# SERVICE INFORMATION LETTER

**Subject:** Spur Gear ID too small causing difficult installation.

Service Information Letter No: 130514-001  
 Page 1 of 3

**Figure 1, Wencor Spur Gear Cross Section View**

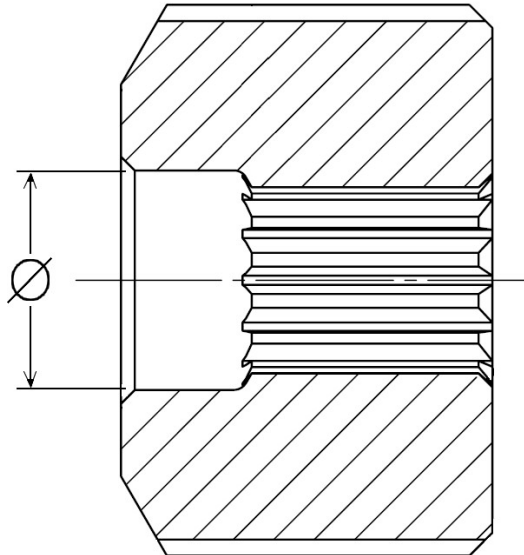
The Wencor Spur Gear was designed with an ID as shown below in Figure 1, which creates a tight fit onto the ATS Turbine Shaft during installation as shown in Figure 2.

The Wencor Spur Gear was designed for an interference fit (.0024 inches max) between the ID of the Spur Gear and the OD of the Turbine Shaft. Due to the small ID on the Wencor Spur Gear and depending upon the OD size of the Turbine Shaft, the installation may require the aid of press tooling or heating of the Spur Gear to fully assembly onto the Turbine Shaft. The component maintenance manual (CMM) does not call out any tooling or heating of the Spur Gear for this assembly process.

The Wencor Spur Gear has been redesigned with a slightly larger ID to create a transition fit, which matches the current design philosophy and allow assembly as described in the CMM.
